ADDENDUM NO. 7
NEW CREAMERY ROAD SEWAGE PUMP STATION
CONTRACT NO. 001

Addendum 7, March 13, 2023.

TOWN OF EMMITSBURG, MARYLAND
NEW CREAMERY ROAD SEWAGE PUMP STATION

NOTE:
 1. ALL CONNECTIONS ARE CONCEPTUAL AND ARE TO BE DESIGNED BY CONTRACTOR IN ACCORDANCE WITH SPECIFICATION SECTION 13120.

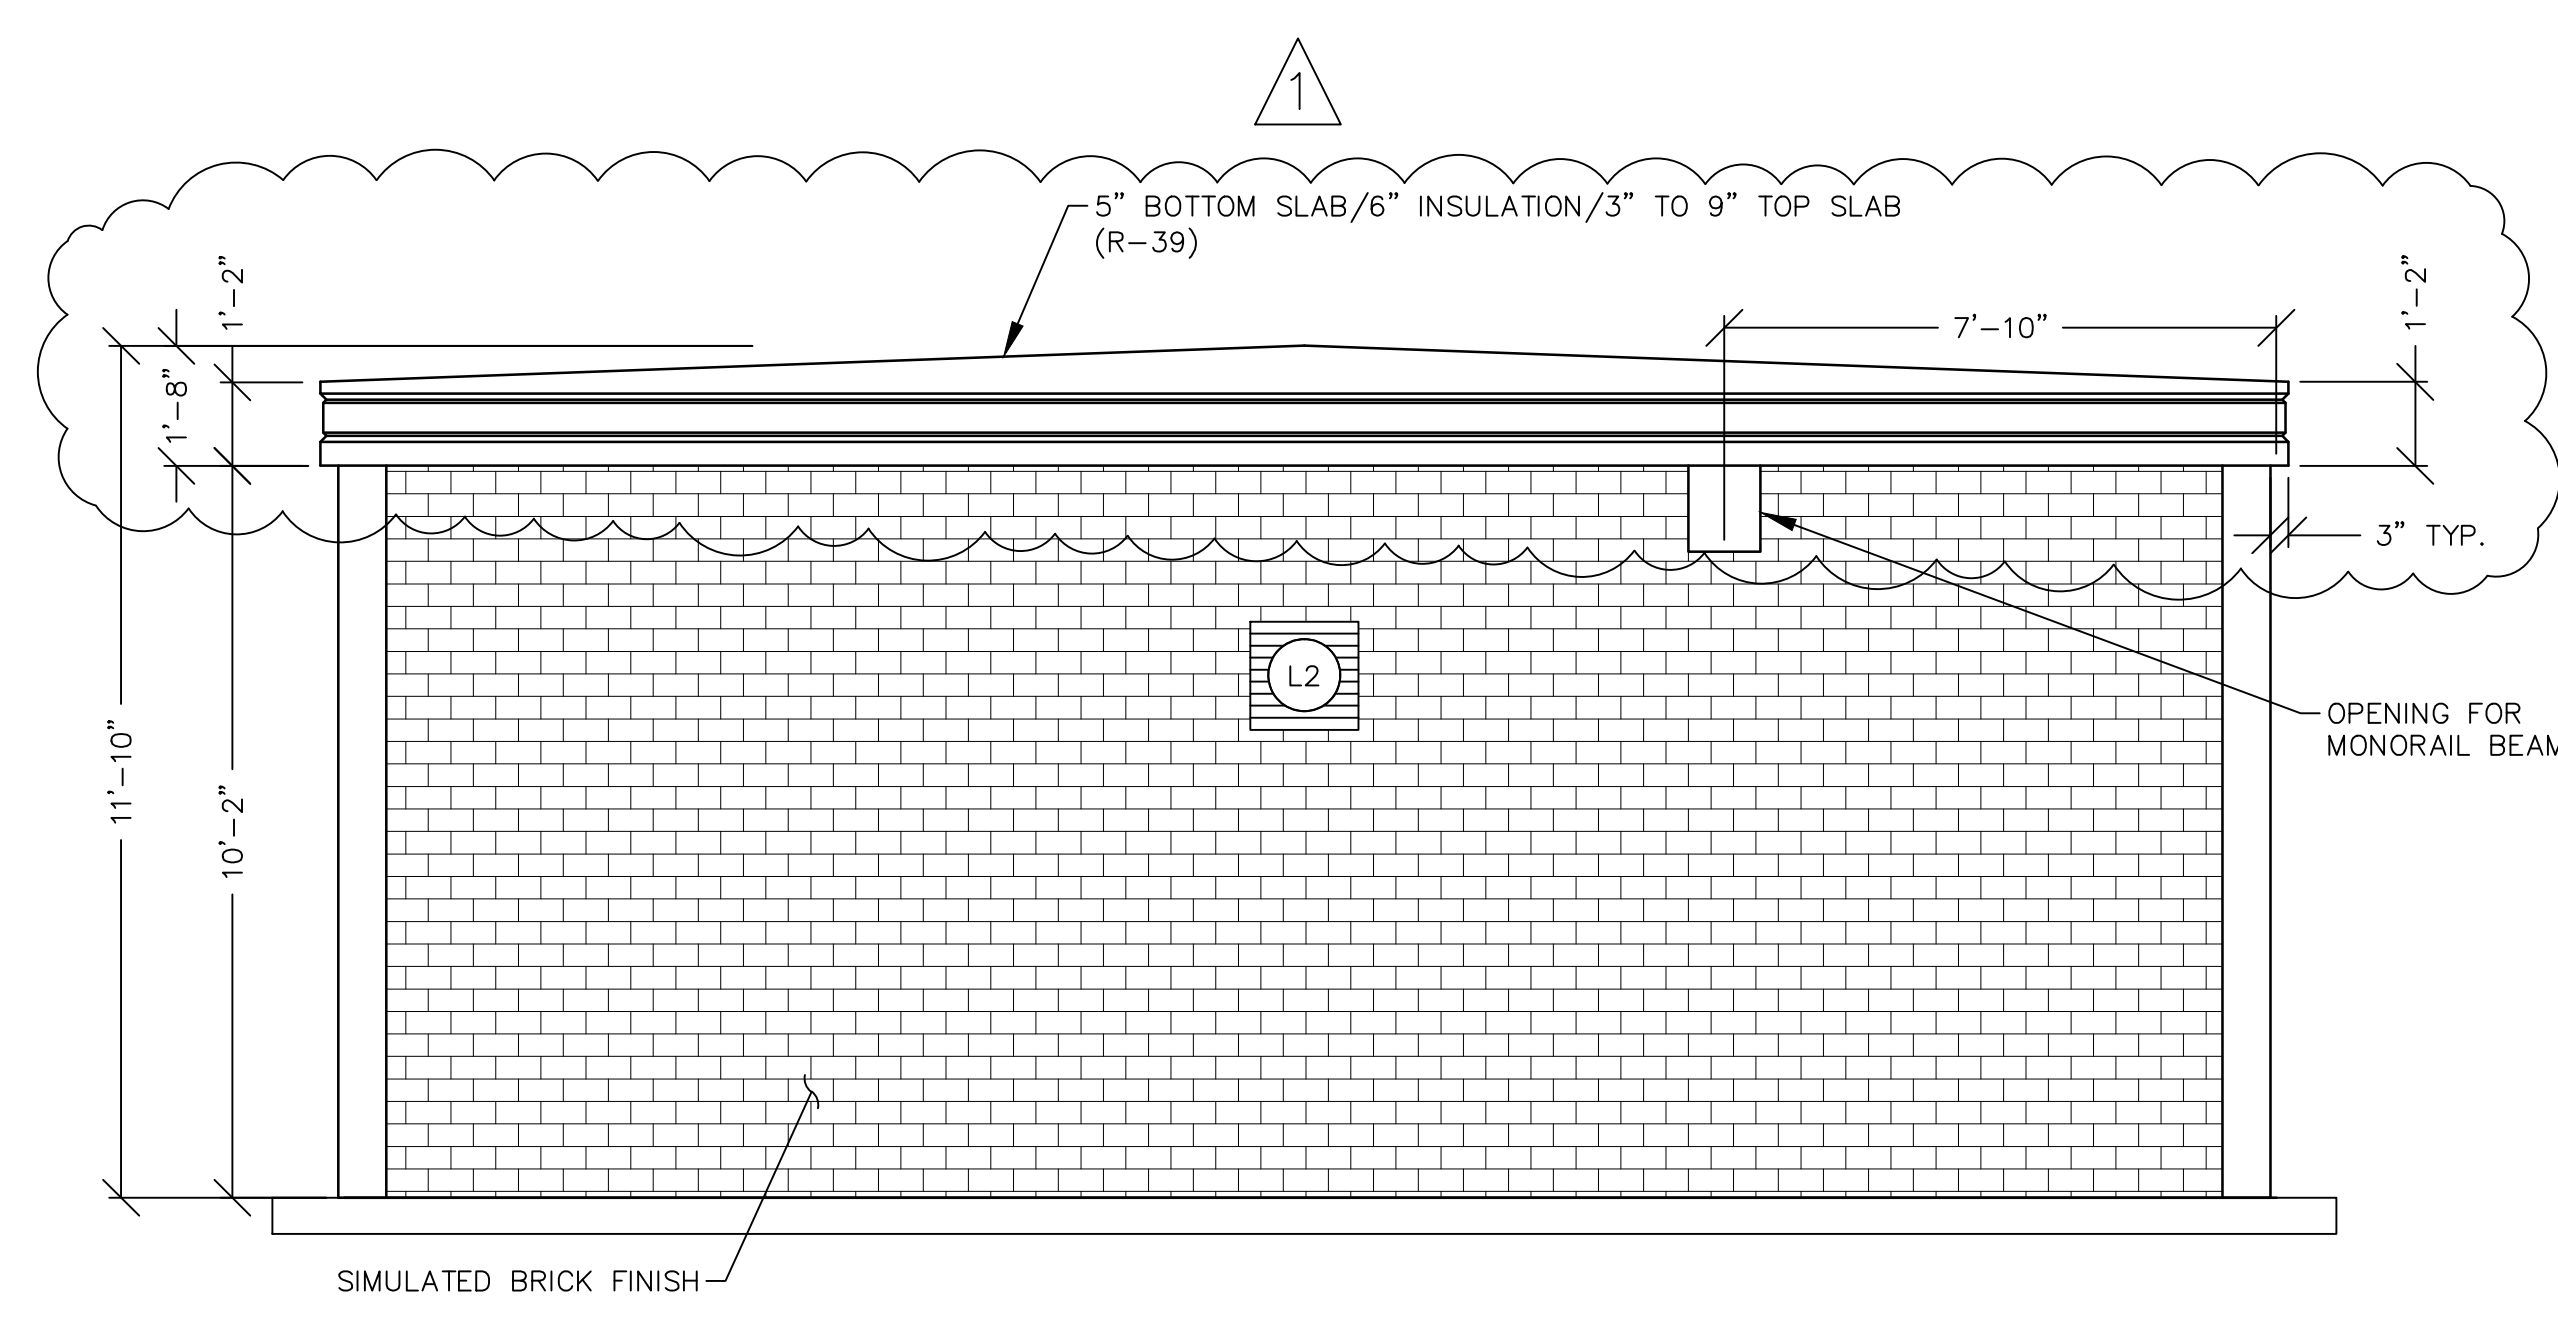
1. The precast concrete building dividing wall shall be MIN 4" and MAX 8" as shown on the attached Sheet S3.
2. The roof slab shall be as shown on the attached revised Sheet S4.
